PRODUCT INFORMATION BULLETIN

The purpose of this bulletin is to inform you of an oil filter design change that has taken place for the 2002 Saturn LS and 2003 VUE with the 2.2L, 4 cyl. Ecotec engine. This change involves a re-designed oil filter housing cap that prevents the incorrect oil filter cartridge from being installed in these applications.

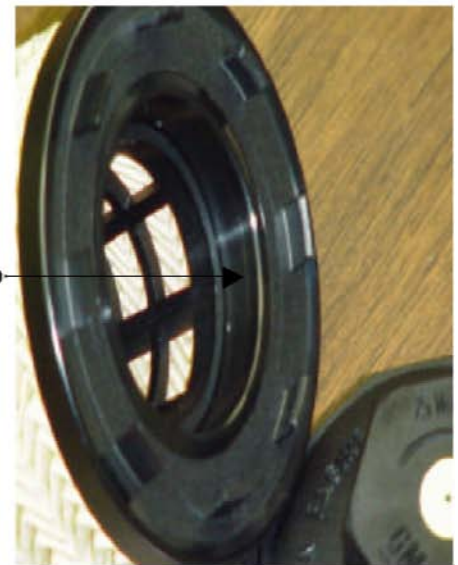
When installing a new oil filter element, ALWAYS attach/snap the new oil filter element onto the oil filter housing cap *before* installing the entire assembly into the oil filter housing on the engine. If the oil filter element does not attach/snap onto the oil filter housing cap, DO NOT attempt to install the assembly into the oil filter housing or engine damage may occur. After the correct oil filter element and oil filter cap are assembled and a light coat of clean motor oil is applied to the oil filter cap sealing gasket, 25 Nm, or 18.5 ft. lbs., of torque is required to properly tighten the oil filter cap onto the oil filter housing. Improper torquing can result in oil leakage and engine damage.
